TECHNICAL EVALUATION REPORT ON THE
TESTS CONDUCTED TO VERIFY THE
ANALYSES PERFORMED ON THE
ADEQUACY OF STATION ELECTRIC
DISTRIBUTION SYSTEM VOLTAGES FOR THE
ARKANSAS NUCLEAR ONE, UNIT 1

(Docket No. 50-313)

8312140428
October 7, 1983

FIGURE 1 - TEST VERIFICATION BUS TRAIN

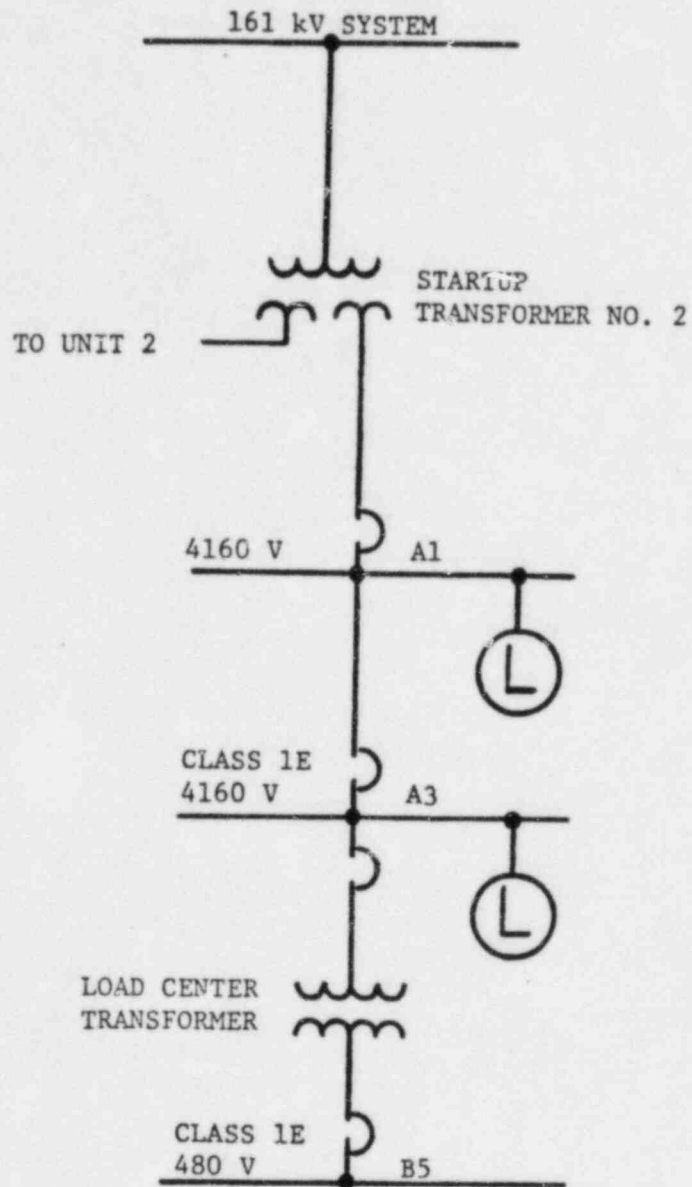
The licensee completed the voltage verification tests during the refueling outage in March 1983 with the plant shutdown and the available grid voltage through Startup Transformer No. 2 [Ref. 3]. A one-line diagram of the buses used in the tests is shown in Figure 1. This train of buses experienced the worst case voltages identified in the voltage profile analyses [Ref. 4].

The results of the two tests showed a worst case percentage error during steady state conditions of 1.09% on 4160-volt Bus A3 and -0.83% on 480-volt Bus B5. For starting transients, the worst case percentage errors on 4160-volt Bus A3 ranged from -0.51% to 0.38% and on 480-volt Bus B5 of -1.08%. A minus percentage error difference indicates the measured voltages were lower than the analytical values.

Applying these percentage errors to the worst case voltages presented in Reference 3, demonstrates that acceptable voltages will be supplied to the Class 1E equipment under worst-case conditions. Thus, these small percentage error differences verifies the accuracy of the program model used in the voltage analyses.
